ADDENDUM 3

ADDENDUM DATE: October 17th, 2024

PROJECT: Orange County Architectural Renovations
Orange County, NC

ARCHITECT: Smith Sinnett Architecture, P.A.
4600 Lake Boone Trail, Suite 205
Raleigh, North Carolina 27607

1 BUILDING B WINDOW DETAILS - HEAD, JAMB, AND SILL
1 1/2" = 1'-0"

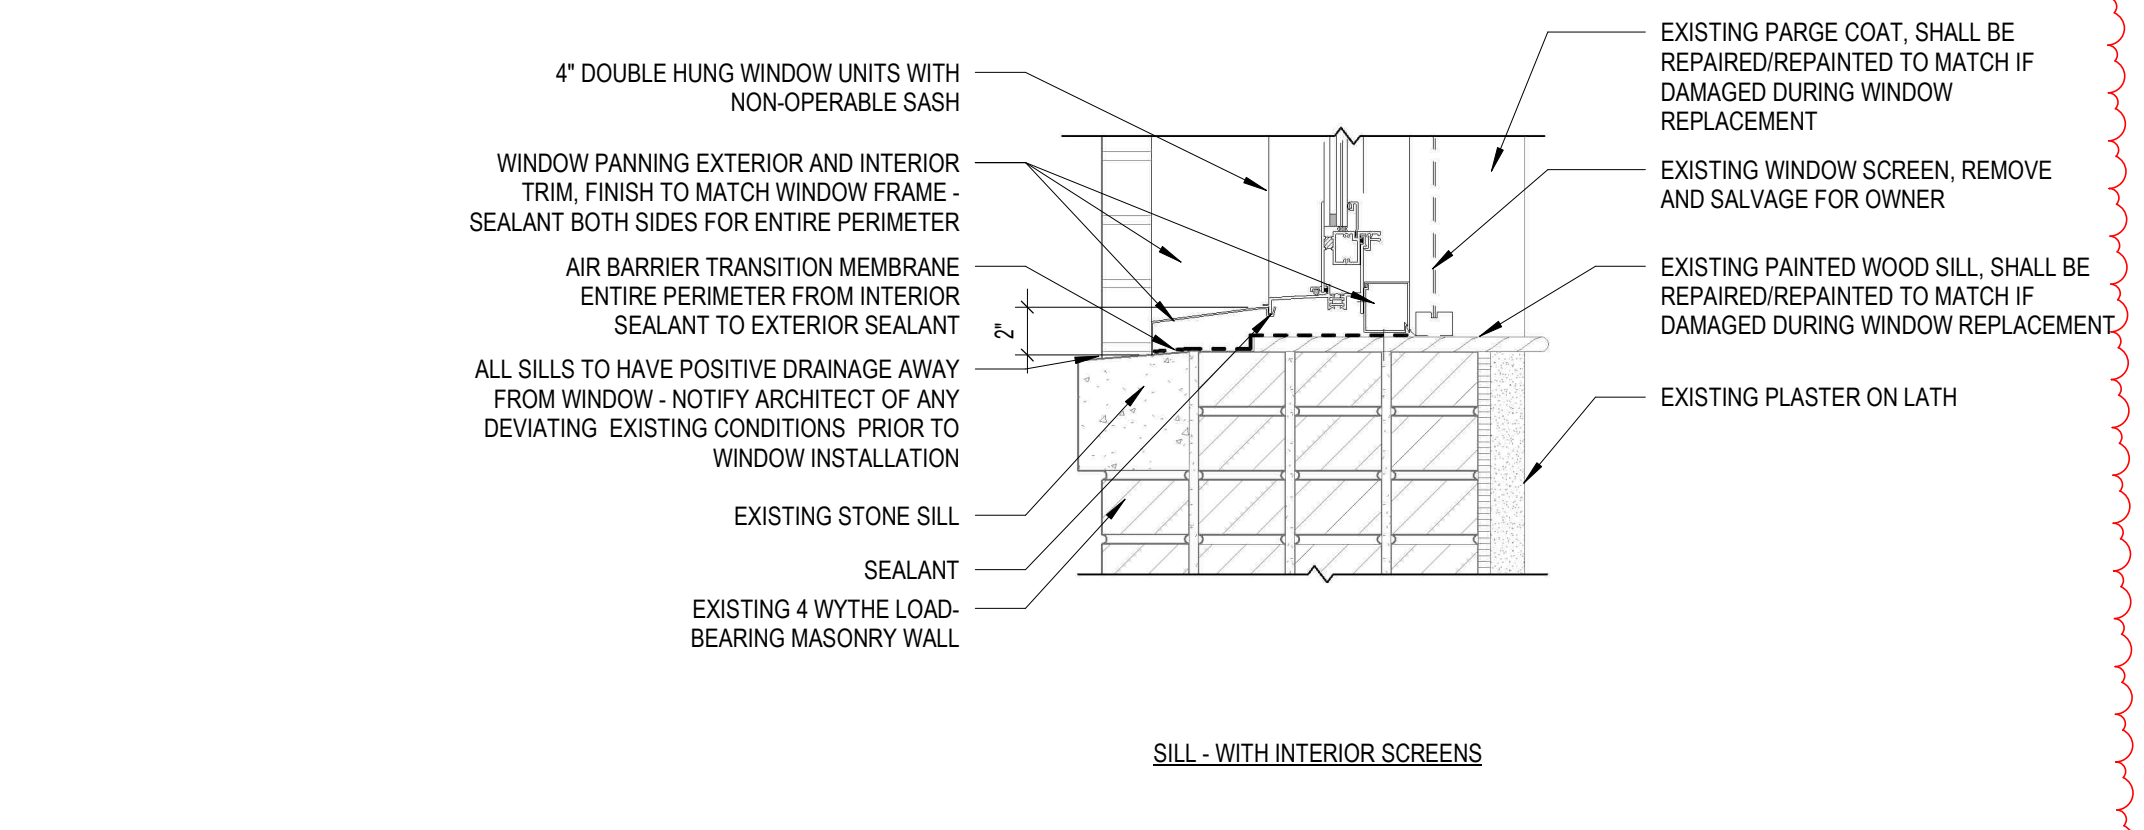
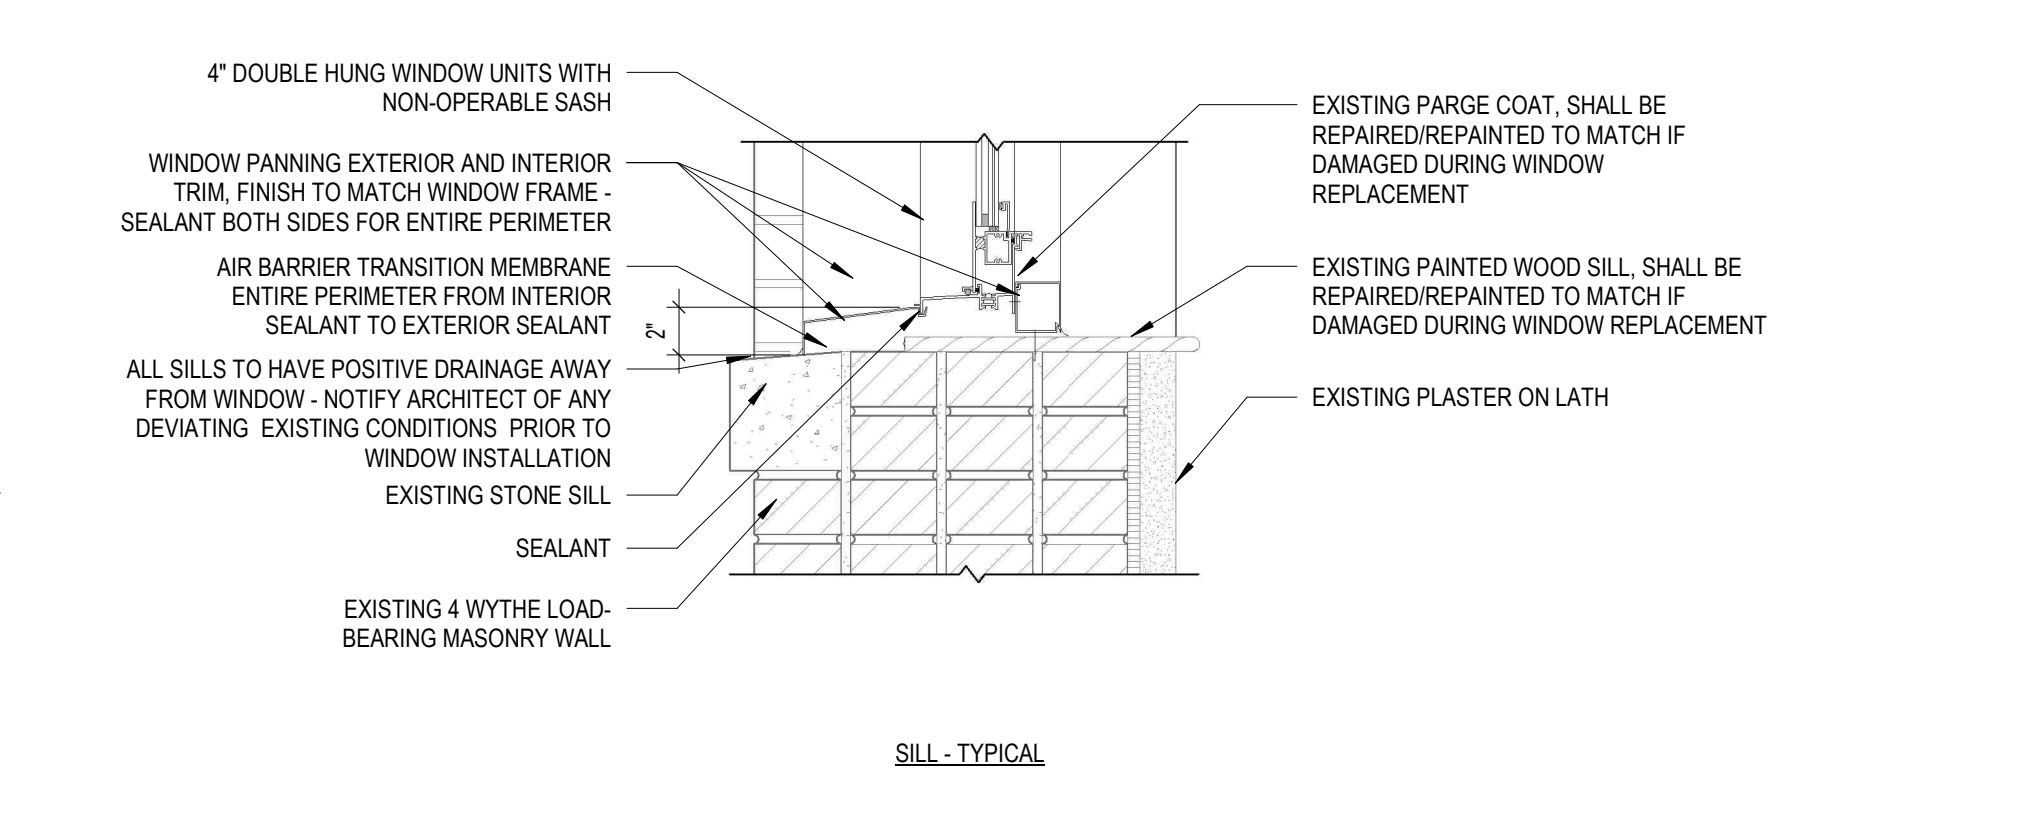
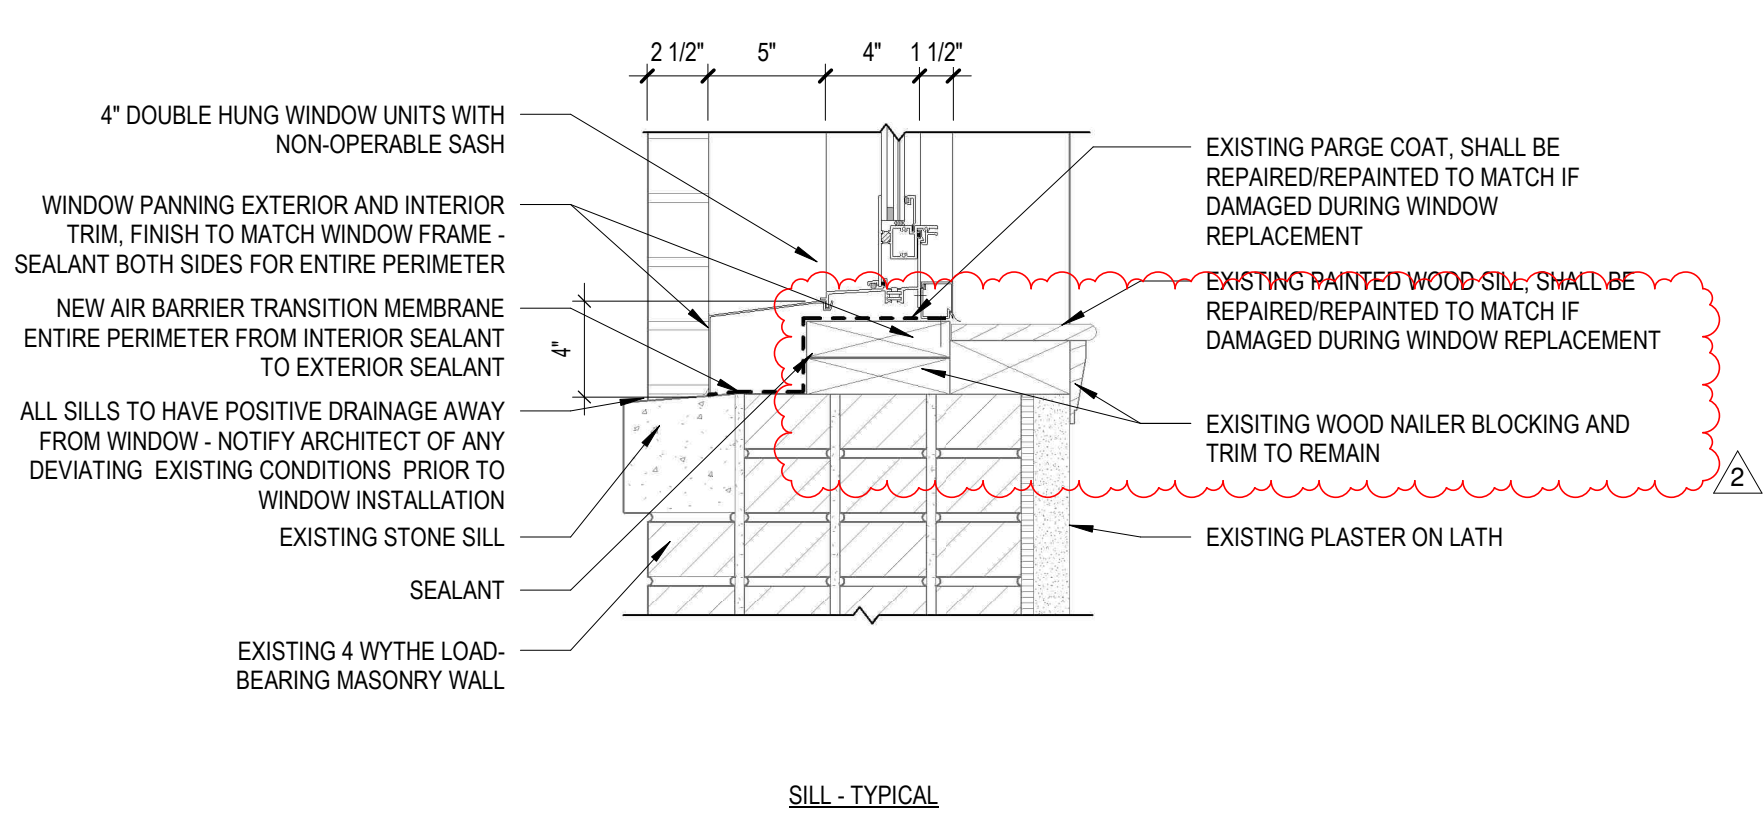
- d. **Revised:** A6-12 – Details Revised to show existing interior frame more accurately with trim and wood nailer blocking to remain. Interior snap trim and exterior panning at full perimeter as shown. Provide necessary connector panning for multi-window assemblies. Cornice details and notes have been revised. Sandblasting is no longer required for prepping cornice for paint.
